Access Compliance Report

Public Rights-of-Way

(Curb Ramps)

Intersection ID: 13541	Main Street: CENTRAL_AV	Cross Street: EASTCREST_DR	Location: NE
ADA ID: F2B6E920D008	Ramp Type: Perp	Initial Pass/Fail: Fail	Overall Compliance: No
Severity Score: 13.75			
Codes/Mitigation Info/Possible Solution		Field Measurements/Component Compliance

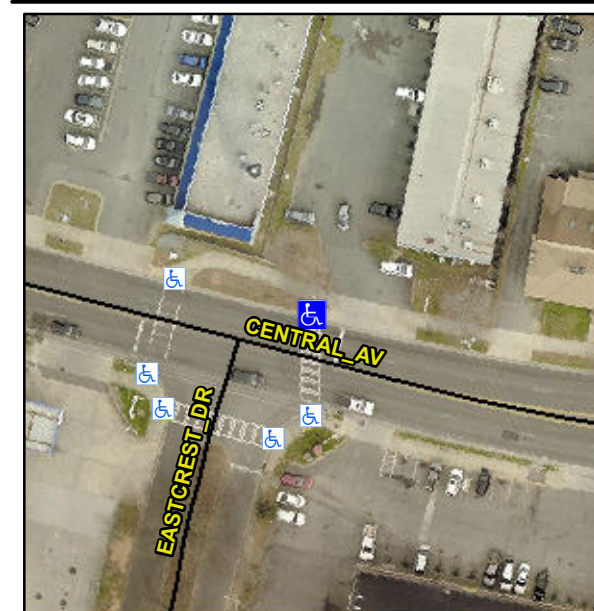
Not Found, R304.2.2

Compliance	Description	Data	Compliance	Description	Data
N/A	Ramp Length (in)	86.0	No	Ramp Slope (%)	8.7
Yes	Ramp Width (in)	51.0	Yes	Ramp XSlope (%)	3.4
N/A	Flare Type LT	N/A	N/A	Flare Type RT	N/A
N/A	Flare Slope LT (%)	N/A	N/A	Flare Slope RT (%)	N/A
N/A	Flare Traversable LT?	N/A	N/A	Flare Traversable RT?	N/A
N/A	Landing Length (in)	N/A	N/A	DWS Provided?	N/A
N/A	Landing Width (in)	N/A	N/A	DWS Contrast?	N/A
N/A	Landing Slope (%)	N/A	N/A	DWS Length (in)	N/A
N/A	Landing X Slope (%)	N/A	N/A	DWS Full Width?	N/A
N/A	Landing Curb? (Y/N)	N/A	N/A	DWS Offset (in)	N/A
N/A	Shared Landing?	N/A			
N/A	Gutter Ponding?	N/A	N/A	Gutter Slope (%)	N/A
N/A	Gutter Lip Ht (in)	N/A	N/A	Gutter X Slope (%)	N/A
N/A	Painted X Walk1?	Yes	N/A	Painted X Walk2?	N/A
	X Walk 1 Direction	To S		X Walk 2 Direction	N/A
N/A	X Walk 1 Width (in)	110.0	N/A	X Walk 2 Width (in)	N/A
	X Walk 1 Slope (%)	6.5		X Walk 2 Slope (%)	N/A
	X Walk 1 X Slope (%)	3.5		X Walk 2 X Slope (%)	N/A

Remove & Replace Entire Ramp.
